CITY OF CAMBRIDGE

BOARD OF ZONING APPEAL

BZA Application Form

LOCATION OF PROPERTY: 1 Longfellow Rd., Cambridge, MA

SCALE	1"=10'			
DATE	REV 4/6/22	REVISED PER CLIENT COMMENT	DK	
03/25/2021	REV DATE	REVISION	BY	
SHEET	1 LONGFELLOW ROAD CAMBRIDGE MASSACHUSETTS			
1	PROPOSED SITE PLAN			
PLAN NO.				
1 OF 1				
CLIENT:				
DRAWN BY				
AU				
CHKD BY				
PJN				
APPD BY				
PJN

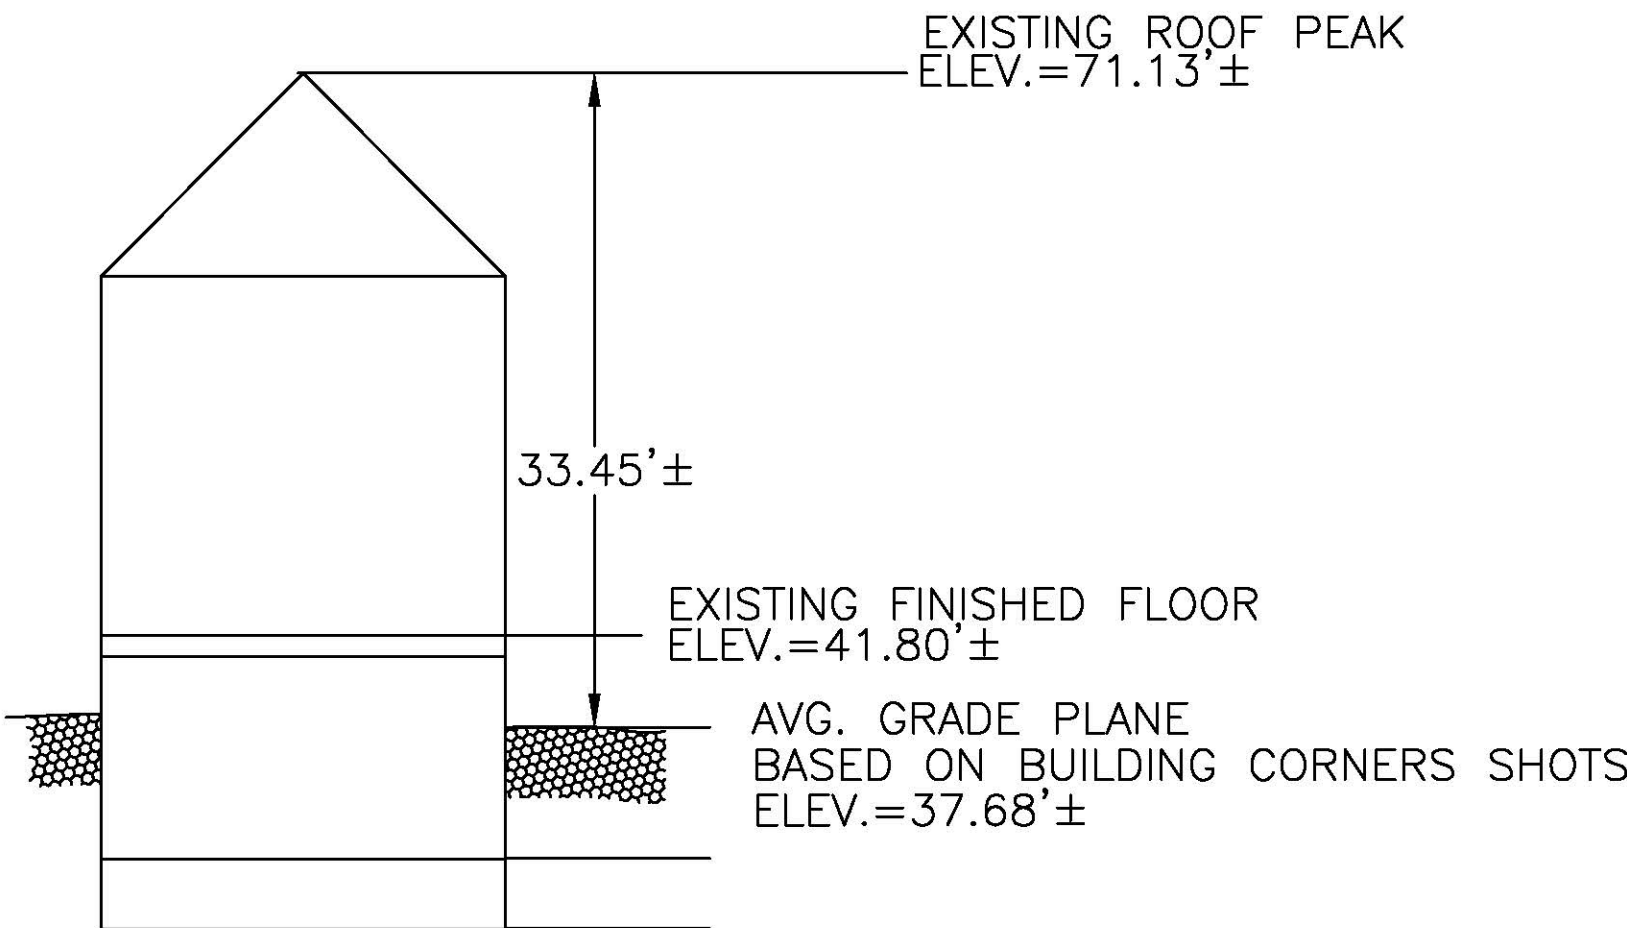
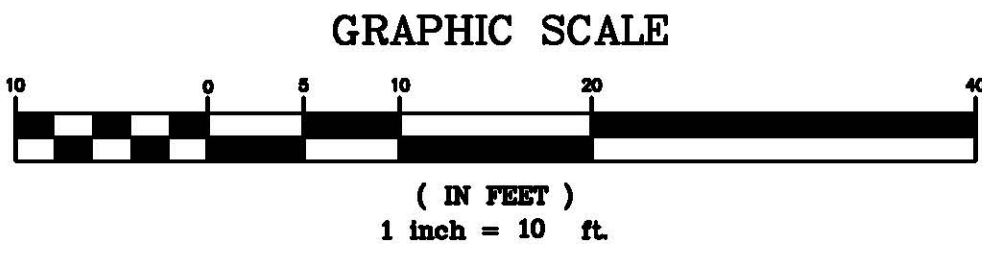
–The updated 4/6/22 Proposed Site Plan by Peter Nolan (originally dated 3/25/21) shows the existing curb but does not show the 2 new window wells. However, it does show a proposed 6-foot high fence along the entire property from the street to the back property line located within the (disputed) Hester property.

David,
While I am waiting for your survey results, I want you to have mine.
I asked Peter Nolan to remove the staircases and the retention walls facing 7 Longfellow Rd.
As shown in the updated survey, my current project does not alter the side entrance facing 7 Longfellow Rd, neither does it alter the current curb line or Hester fence.
Please send me your survey results when you get it.
Best,

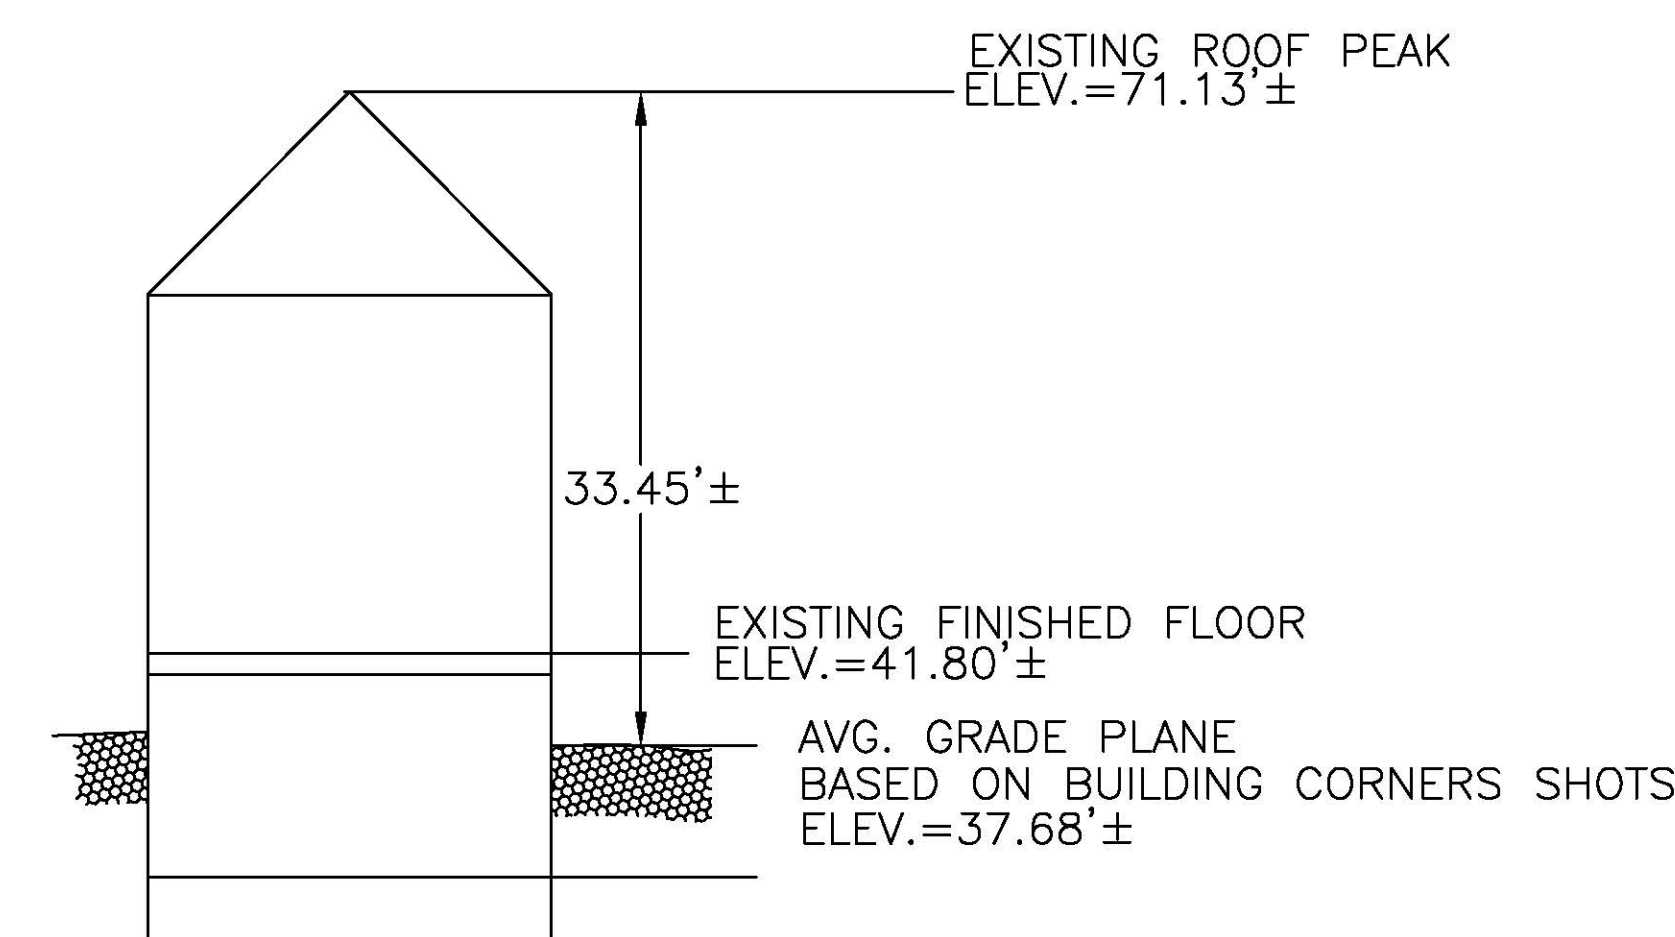
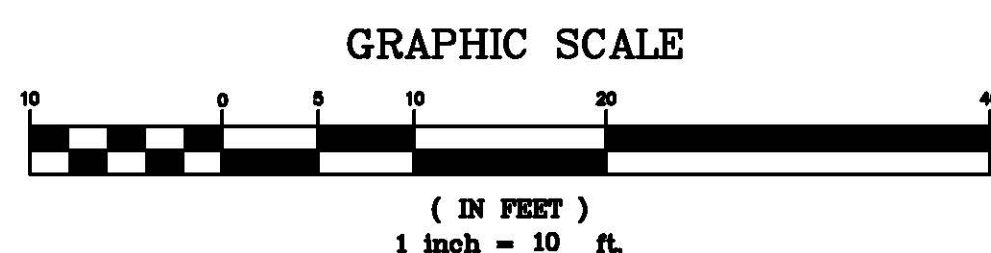
—The updated 4/6/22 Proposed Site Plan by Peter Nolan (originally dated 3/25/21) shows the existing curb but does not show the 2 new window wells. However, it does show a proposed 6-foot high fence along the entire property from the street to the back property line located within the (disputed) Hester property.
